## Planning Commission Staff Report

<b>Project Type:</b>	Site Development Section Plan
<b>Meeting Date:</b>	December 10, 2018
<b>From:</b>	Andrew Stanislav, Planner <i>AS</i>
<b>Location:</b>	17690 Edison Avenue
<b>Description:</b>	<b>Edison Crossing, Lot 1 (Little Sunshine's Playhouse):</b> A Site Development Section Plan, Landscape Plan, Lighting Plan, Architectural Elevations and Architect's Statement of Design for a 1.27 acre tract of land zoned "PC" Planned Commercial District located at the southeast corner of the intersection of Edison Avenue and Long Road within the Edison Crossing subdivision.

Re: Little Sunshine's Playhouse – 17690 Edison Ave.  
TR,i Project #: 17-117  
ARCHITECT'S STATEMENT OF DESIGN

**Landscape Plan**  
SCALE 1"=20'

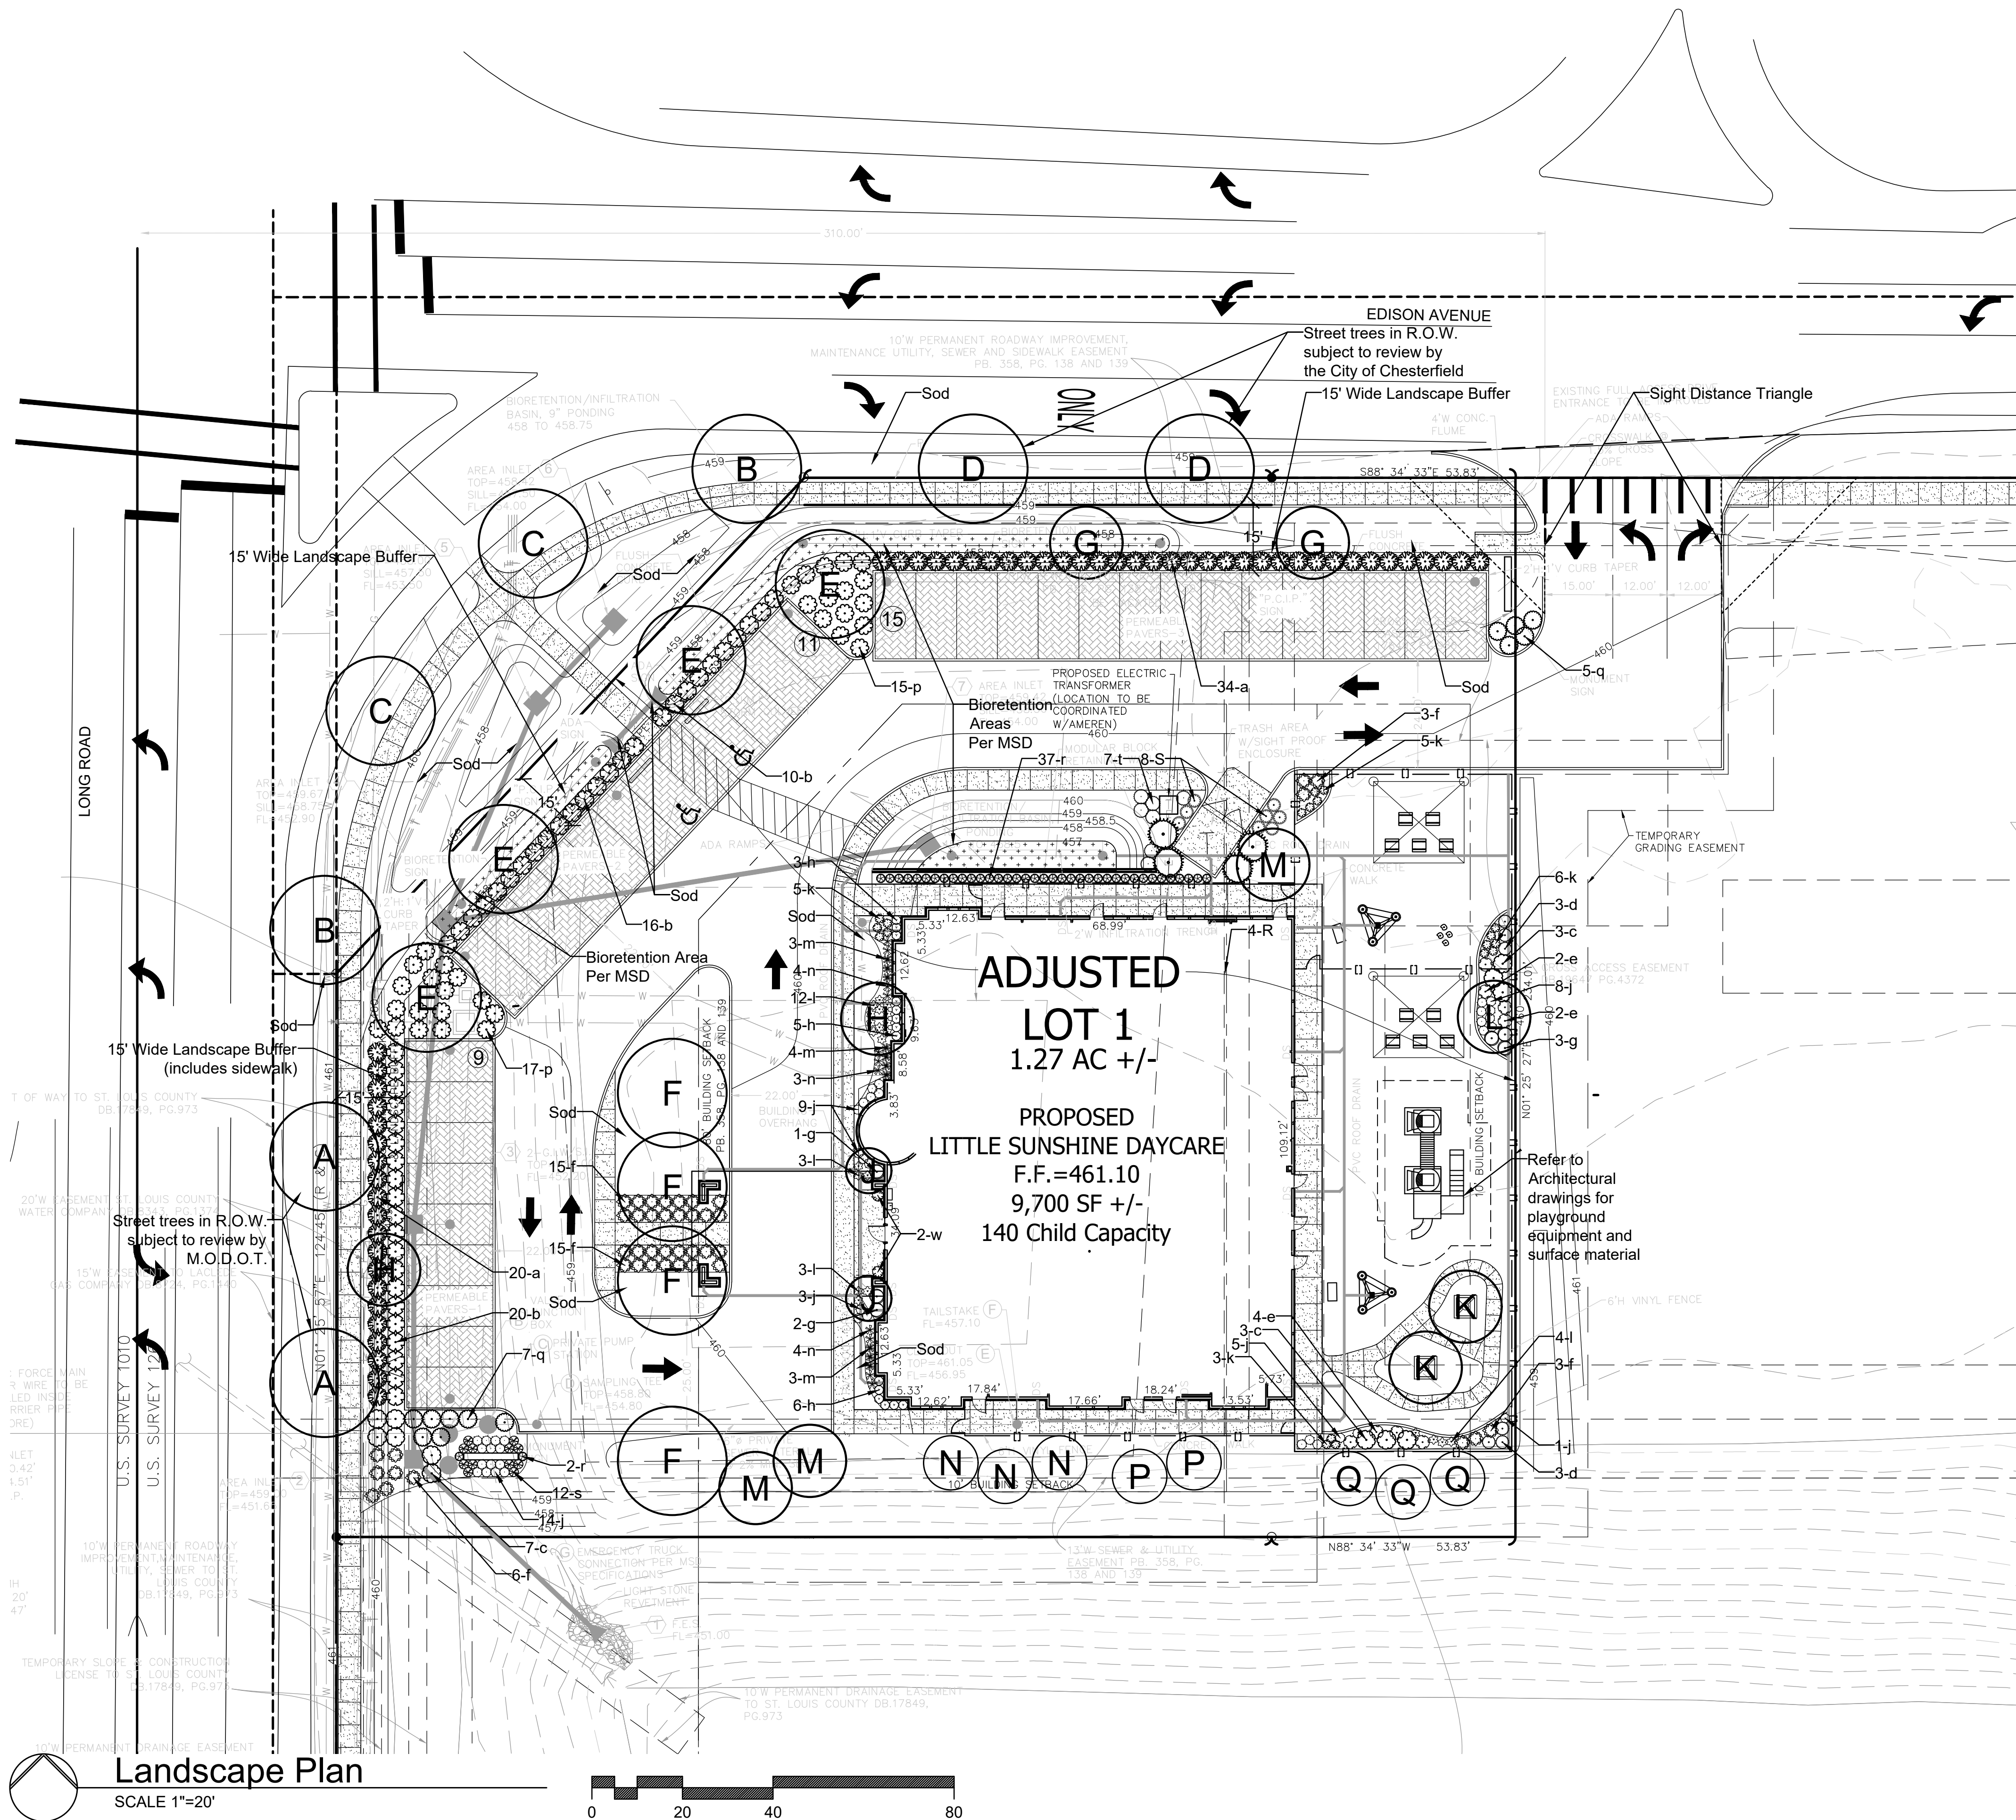
- **Provide junipers on both the east and west side of the dumpster enclosure.**

The applicant has revised the original Landscape Plan to incorporate two junipers on each side of the dumpster enclosure (east and west) to provide a more balanced and thorough screening as intended by the ARB.
